Ref.: AN 4/1.1.57-17/44

**Subject:** Proposals for the amendment of Annex 14,  
Volume I and PANS-Aerodromes (Doc 9981)

*As part of the Annex 14 — Aerodromes, Volume I — Aerodrome Design and Operations, Chapter 3 review, the aerodrome design specifications were extensively discussed within the Aerodrome Design and Operations Panel (ADOP). In general, the ADOP had considered that the existing specifications were derived before the advent of modern, new large aircraft and that they were overly conservative. In light of the foregoing, the second meeting of the ADOP (ADOP/2) concluded that based on various studies conducted in different States and international organizations, the work was comprehensive and its proposal well justified, and this was also agreed to by the Air Navigation Commission.*

Rwy widths/shoulders (Code D and E)

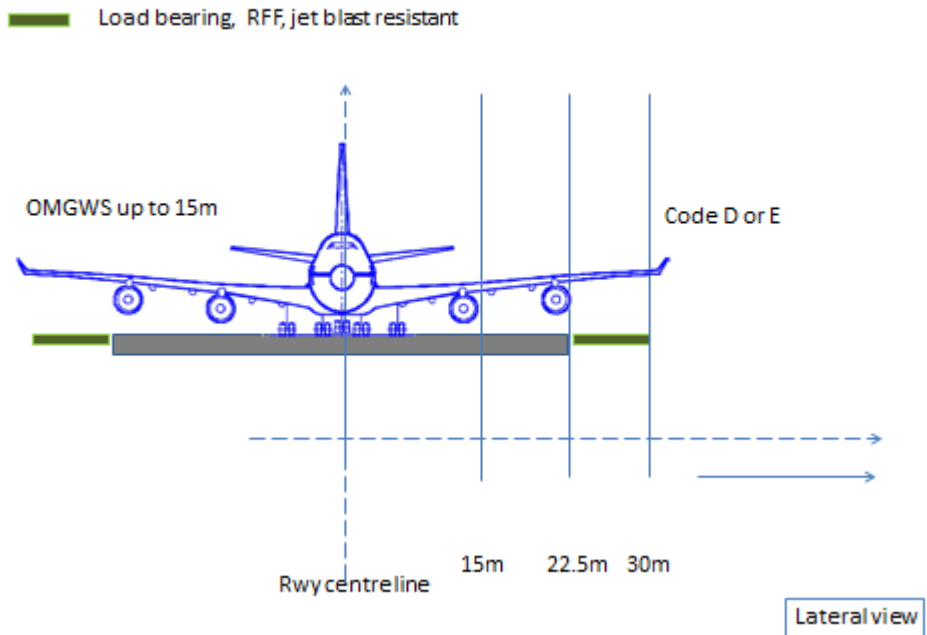
### 1. Runway widths and shoulders (Annex 14, Volume I, paragraph 3.1.10)

1.1 The following diagrams show the different runway and shoulders for OMGWS above 6m and up to 15m (covering nearly all commercial aeroplanes, Codes C, D, E and F)

2. Taxiway widths and shoulders (Annex 14, Volume I, paragraphs 3.9.3, 3.9.4 and 3.10.1)

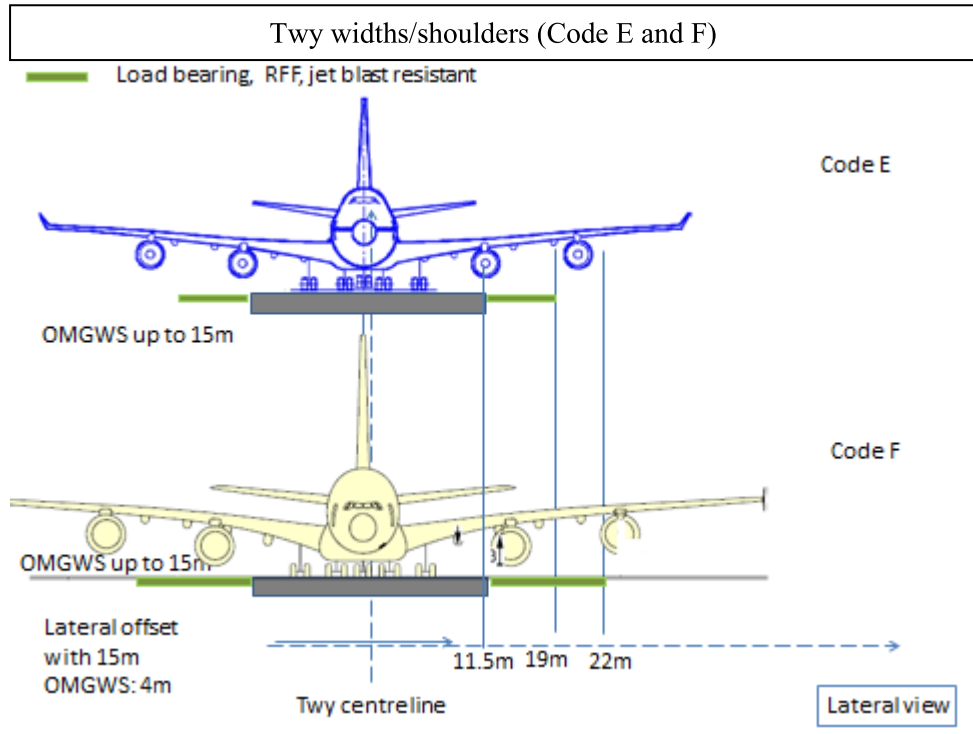
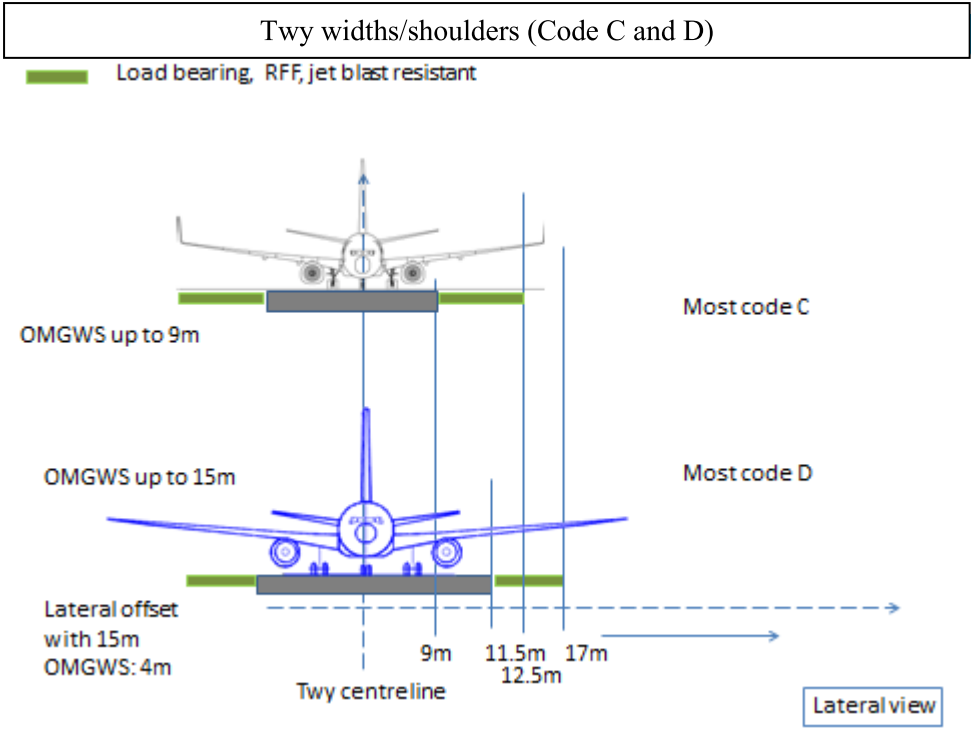
2.1 The following diagrams show the different taxiway and shoulders for OMGWS above 6m and up to 15m (covering nearly all commercial aeroplanes, Codes C, D, E and F).

**3. Widths of runway strips for precision and non-precisions runways (paragraphs 3.4.3 and 3.4.4)**

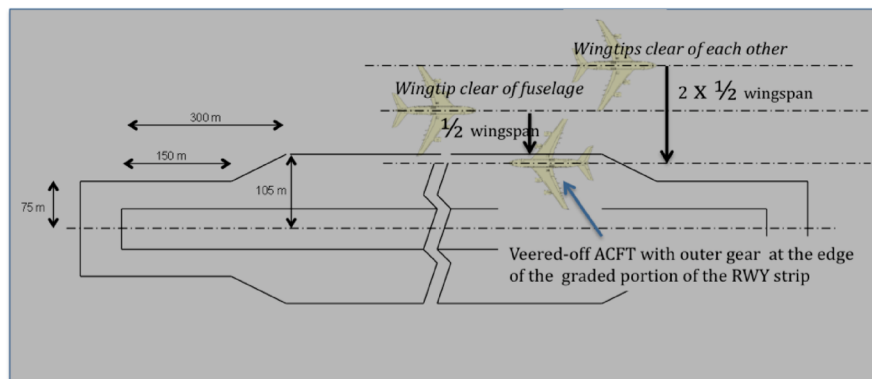
3.2 For runways with precision approaches, the half-width of the graded portion of the strip is recommended to be between 75 and 105m, depending on the distance from the threshold. Using the higher value, this yields separations of (see figure below):

- a) For “protection” against wing-tip to fuselage contact (catastrophic):  
 $\frac{1}{2}$  width of graded area +  $\frac{1}{2}$  wingspan =  $105 + 40 = 145\text{m}$
- b) For “protection” against wing-tip to wingtip contact (major):  
 $\frac{1}{2}$  width of graded area –  $\frac{1}{2}$  gear span +  $\frac{1}{2}$  wingspan +  $\frac{1}{2}$  wingspan =  $105 - 7 + 40 + 40 = 178\text{m}$

(runway aircraft with its outer gear at the edge of the graded area)

- c) it shows that the worst case leads to a minimum runway-taxiway separation of 178m for code F, allowing for the extremely improbable deviation of an aircraft on the runway to the edge of the graded portion of the strip;
- d) this minimum runway-taxiway separation is rounded up from 178 to 180m;
- e) the 180 m includes the half wingspan of the aircraft on the taxiway (corresponding to 140m half strip + 40m half wingspan)
- f) thus, full protection is achieved with a half strip width of 140 m.

Graded portion of a taxiway strip in relation to taxiway to object distance according to Table 3-1 .

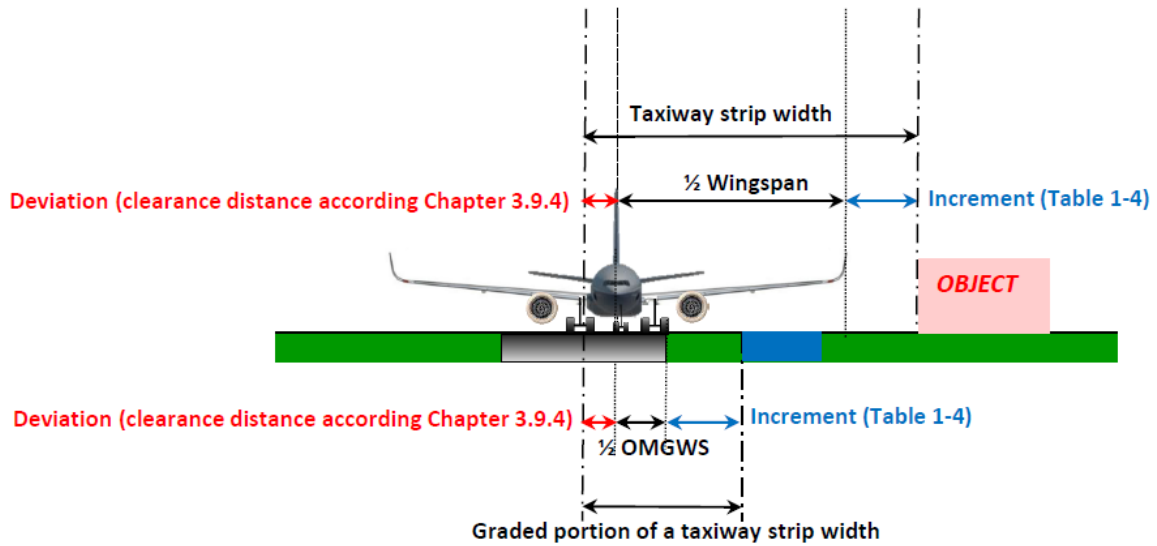
4.1 The objective of the graded portion of a taxiway strip is to reduce the risk of damage to an aeroplane accidentally running off the taxiway, and should therefore be expressed in terms of OMGWS, while the taxiway to object values (Table 3-1) are expressed in terms of wingspan.

4.2 The current graded portion of the taxiway strip includes a by far larger safety buffer than the taxiway to object separation distance required for ensuring wingtip clearance. In practice, this means that an aircraft could travel on an area prepared to occasionally withstand its weight and hit an object far before leaving the graded portion of a taxiway strip. It is proposed to harmonize the values with table 3-1 according to the formula:

$\frac{1}{2}$  OMGWS + deviation + increment

4.3 The proposed values are consistent with the revised taxiway separations distances in Table 3-1 as per Amendment 13, Annex 14, Volume I. The proposed amendment simplifies the application of airport planning standards as well as allowing a more efficient use of aerodrome land surface by applying the same safety level for a wingtip collision as for getting beyond the graded portion of a taxiway strip in case of an excursion.
